Pentium® II Xeon™ Processor Specification Update

Release Date: January 1999

Order Number: 243776-009

The Pentium® II Xeon™ processor may contain design defects or errors known as errata which may cause the product to deviate from published specifications. Current characterized errata are documented in this Specification Update.

Figure 2. Workaround Flowchart: SMBALERT#-Driven System

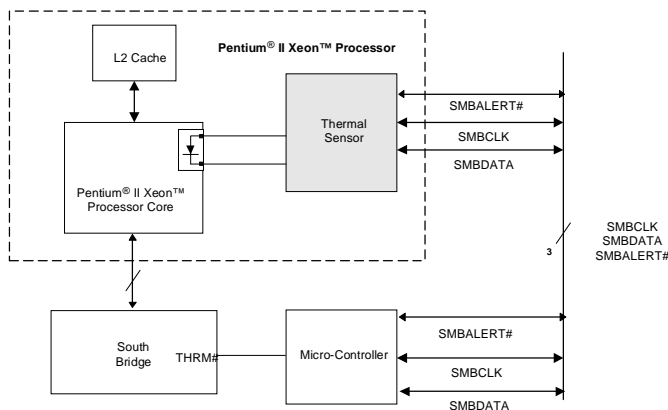
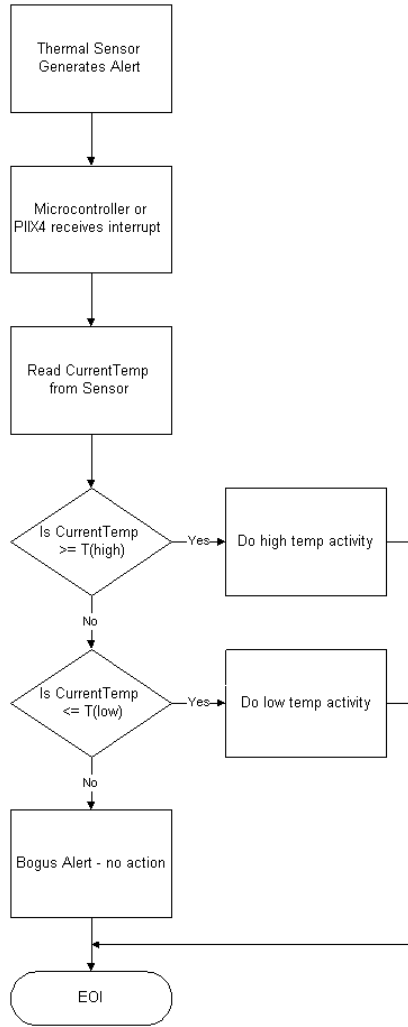
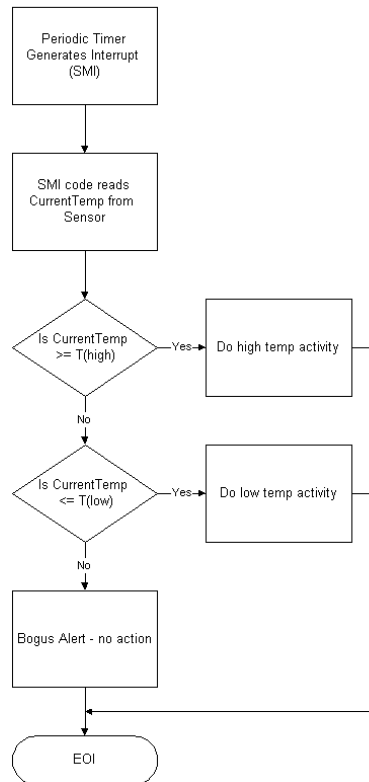
D30. Thermal Sensor May Assert SMBALERT# Incorrectly

PROBLEM: The Pentium II Xeon processor has a thermal sensor that monitors the processor core's temperature. The thermal sensor asserts SMBALERT# if the processor temperature exceeds the temperature limits set in the Alarm Threshold Registers (T_{HIGH} , T_{LOW}). It also sets the corresponding Status Register bits to identify the cause of the interrupt. Figure 1 gives one example of the how the SMBALERT# signal could be used in a system.

Under the conditions described below, the thermal sensor incorrectly generates the SMBALERT# interrupt. *All* of the following conditions must be met to trigger a false interrupt:

WORKAROUND: Three different (mutually exclusive) workarounds are possible:

1. Before servicing an interrupt from the thermal sensor, read and compare the processor thermal reading with the threshold limits (T_{HIGH} or T_{LOW}). Figures 2 and 3 provide basic flowcharts for the implementation of this workaround in an interrupt driven system.
2. If the firmware implemented polls the Status Register only, then before taking any action, re-read the temperature register and do a comparison with the alarm threshold limits (T_{HIGH} or T_{LOW}) to determine if the value is actually still within the temperature window.
3. Use a temperature polling scheme to monitor the processor temperature.
